**MT. SAN JACINTO COMMUNITY COLLEGE DISTRICT**

**ADDENDUM NO. 1**

**Bid No. 2019-011**

**Temecula Valley Campus Electrical Construction Separation**

1 (E) EMH-1 DEMOLITION PLAN  
NO SCALE

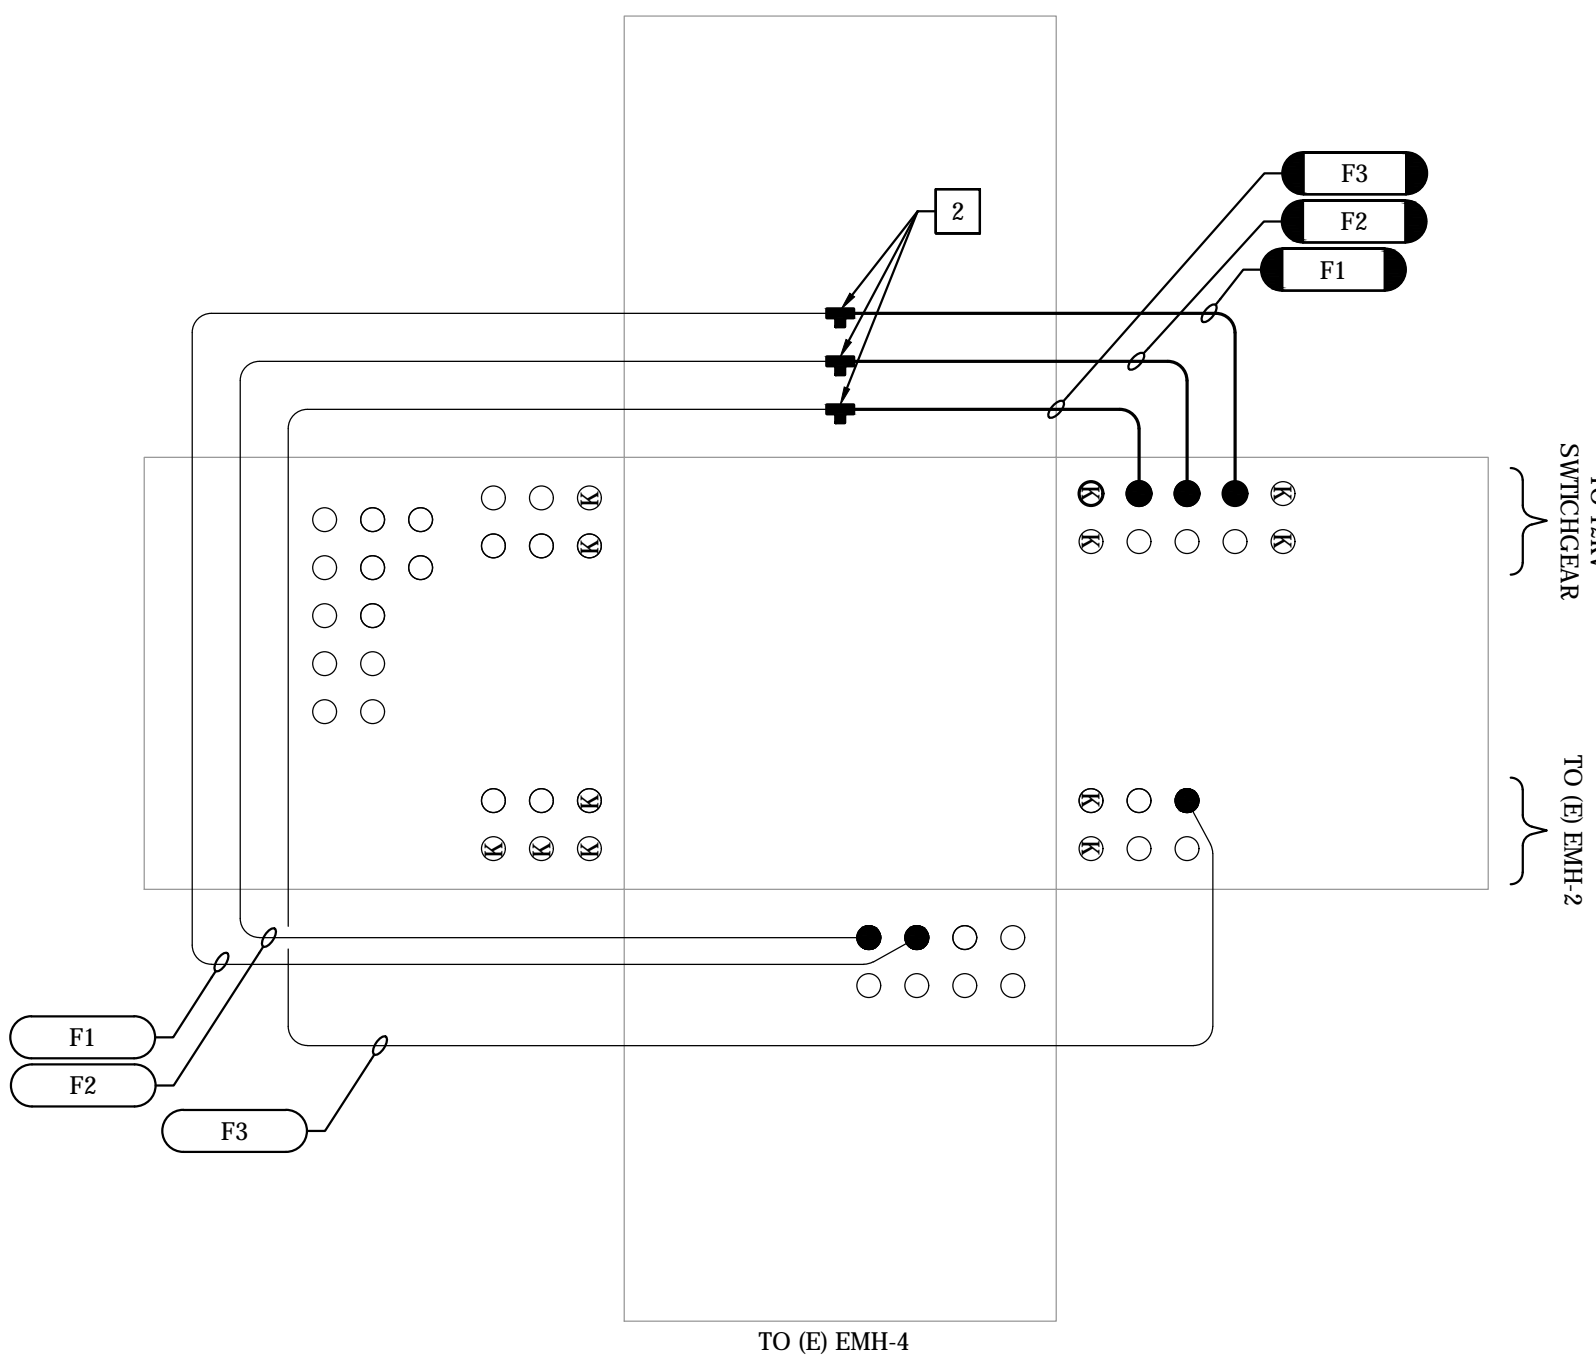
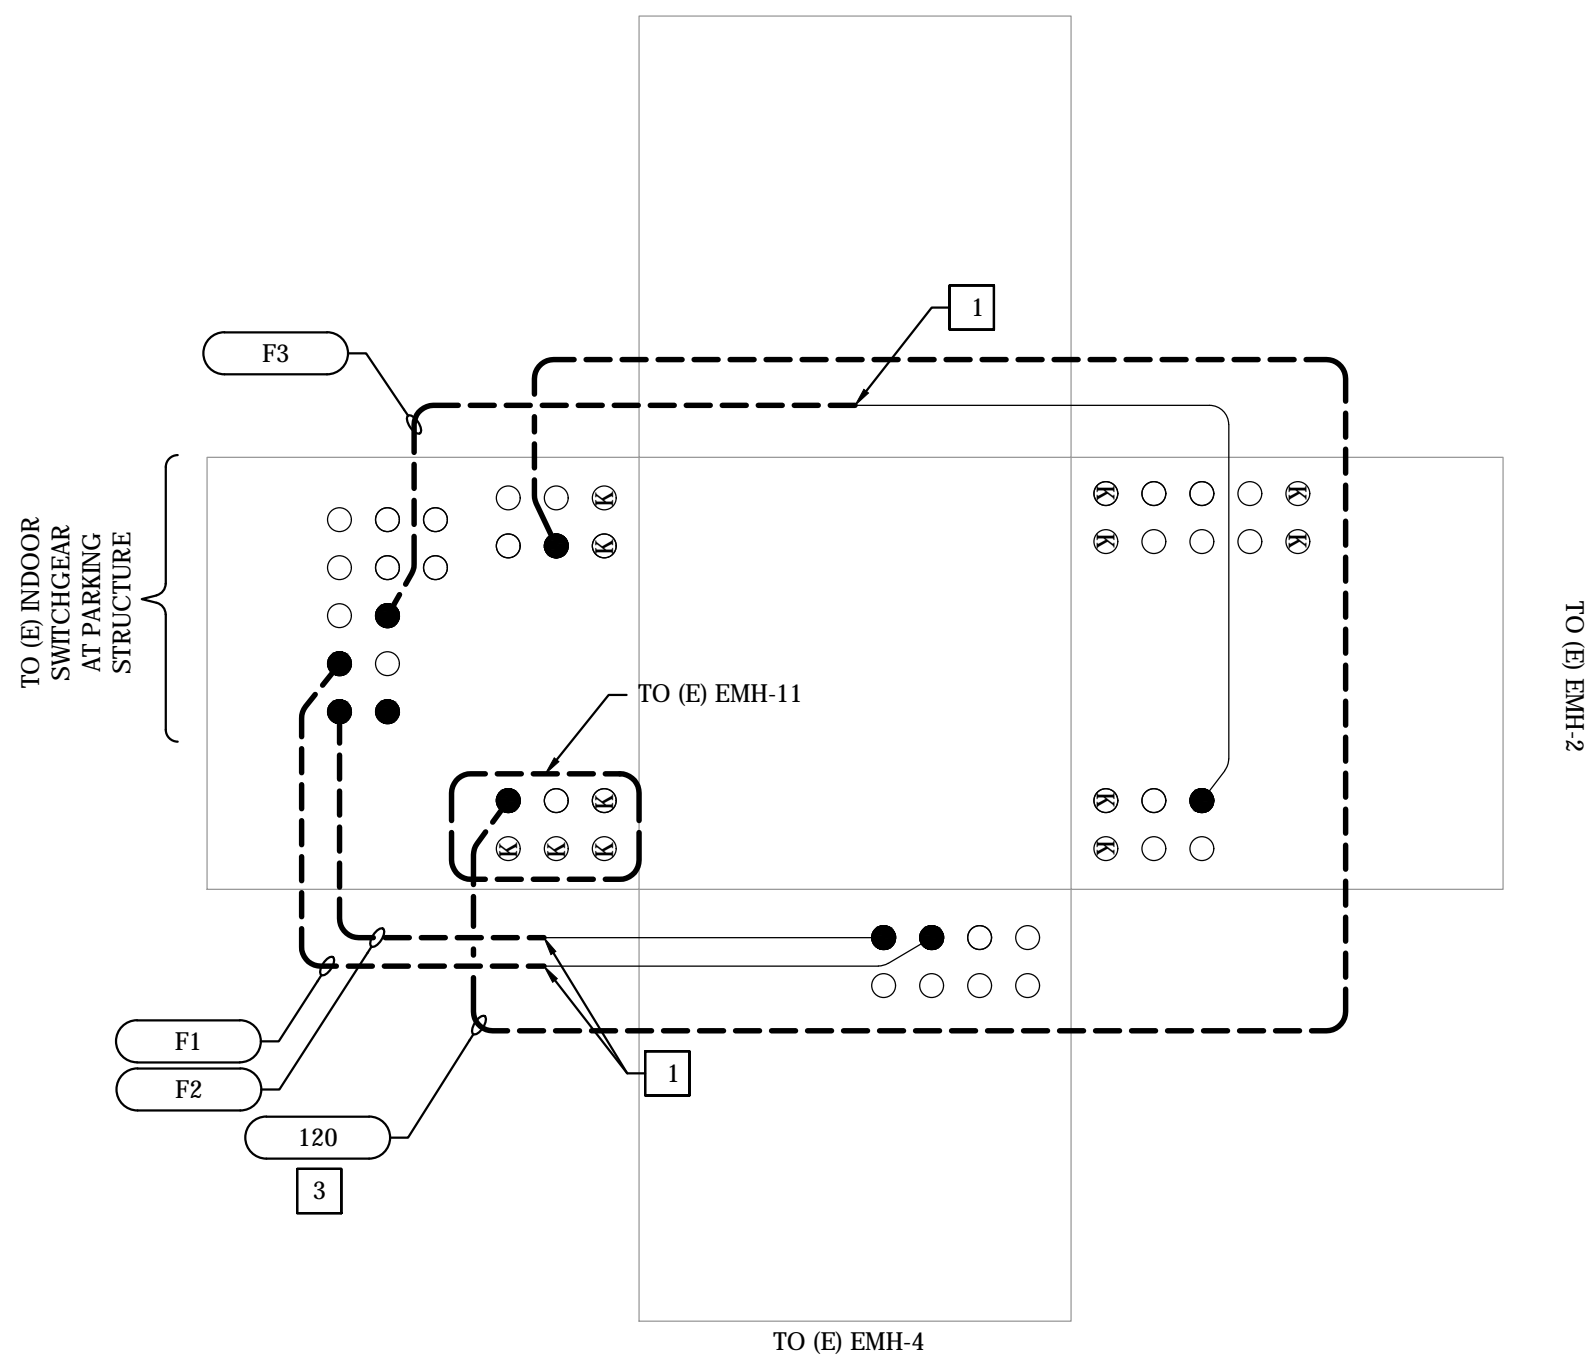
- Q3. Is there terminations in Existing Electric Manhole 11 which is on college side of Ynez Road which MV Cables could be saved off?  
A3. Demolition of feeder 120 shown on manhole profile EMH-1 on sheet E701 is for reference only. Feeder 120 will be demolished as part of a separate project and is not within the scope of this project.
